STATE OF HAWAII
DEPARTMENT OF LAND AND NATURAL RESOURCES
OFFICE OF CONSERVATION AND COASTAL LANDS
Honolulu, Hawai'i

June 9, 2017

REGARDING: Conservation District Use Application OA-3784
Royal Hawaiian Groin Improvement Project

APPLICANT: Department of Land and Natural Resources

Existing Groin Repair

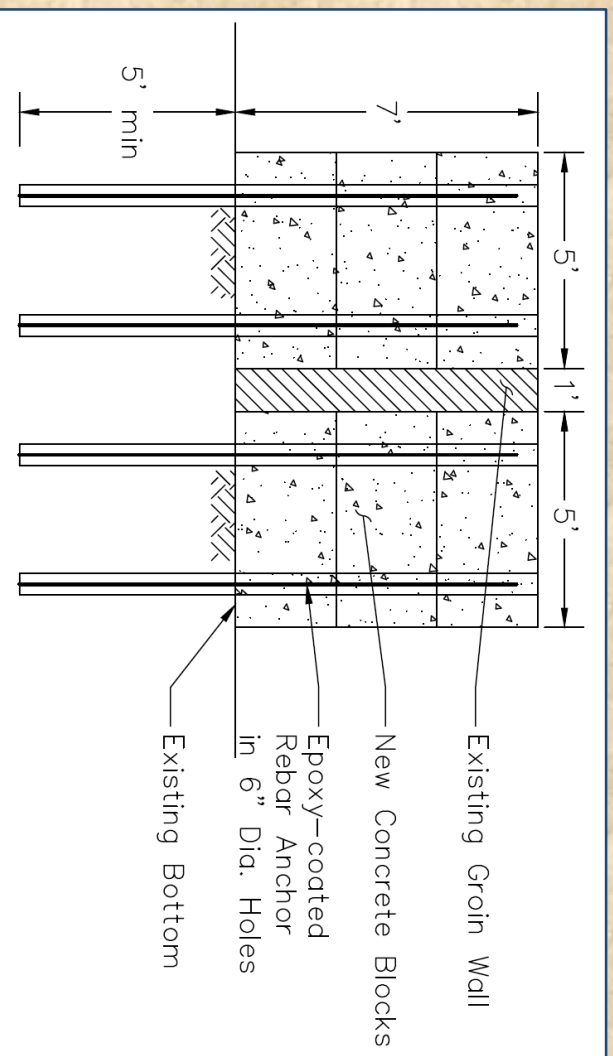
- Structural analysis determined that the existing RHG cannot withstand the design wave forces
- Strengthening existing wall to withstand design wave forces requires 5' wide by 7' tall concrete blocks on both sides of the existing wall

Shf B1/B5

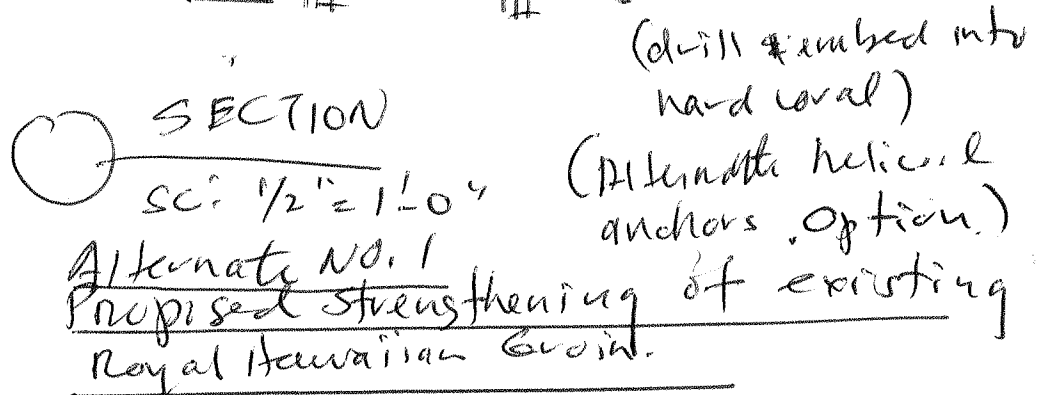
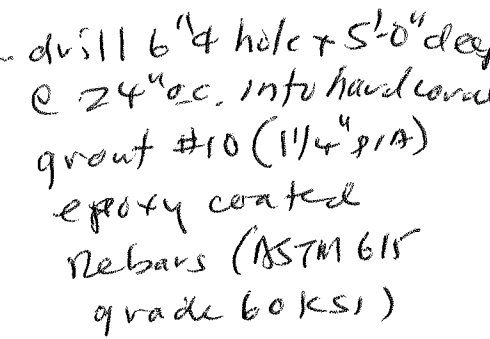
SF $\text{Safety Factor}_{\text{overturning}} = \frac{525}{2283} = 0.23 < 1.0 = \text{neutral stability}$

Recommended S.F. = 2.0

NO GOOD

Exist wall overturning SF < 2.0
 wall will overturn and fail -
 wall will need to be stabilized
 with added strengthening

PROPOSED STRENGTHENING OF
EXIST. ROYAL HAWAIIAN GROIN

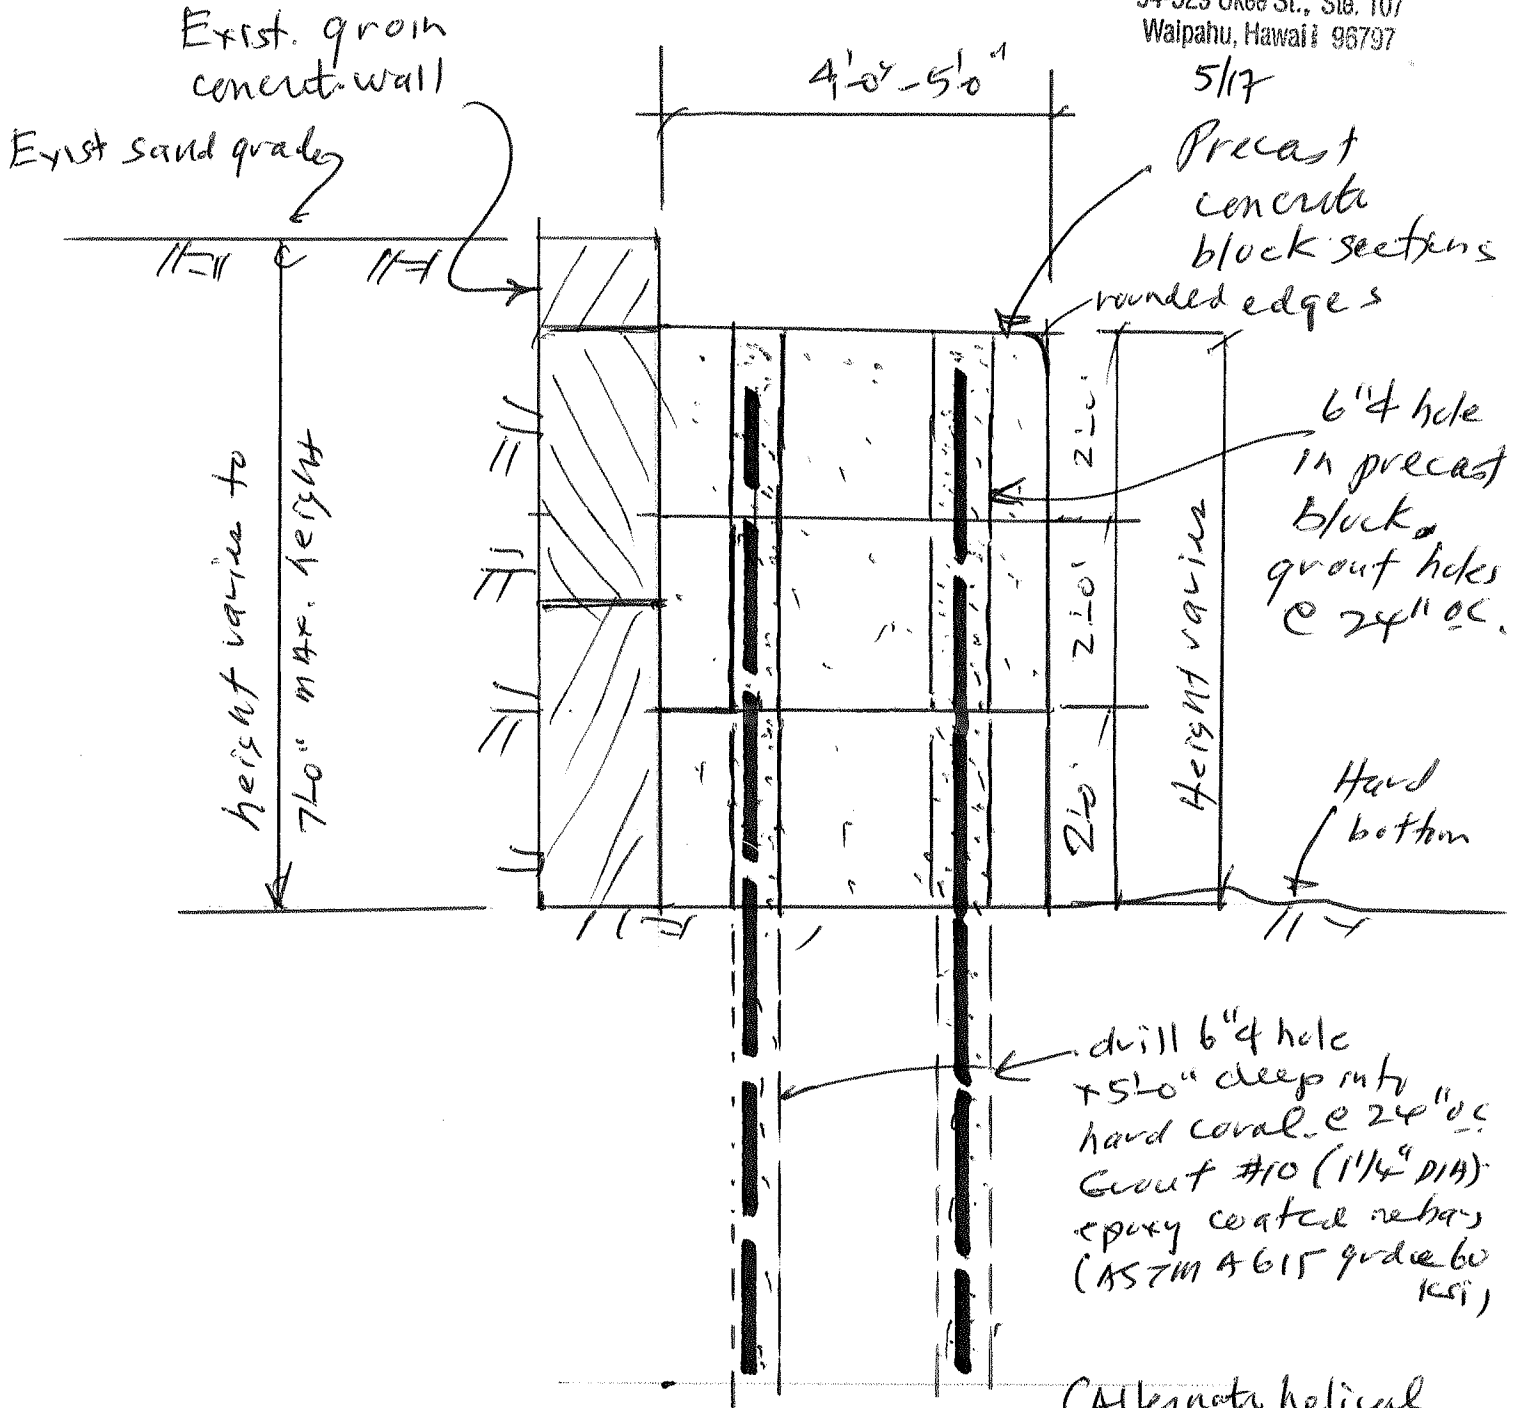
Safety factor against overturning, $SF = \frac{36,652}{18,340} = 2.0$
 (neglect 5' x 7' concrete block each side) ≈ 2.0
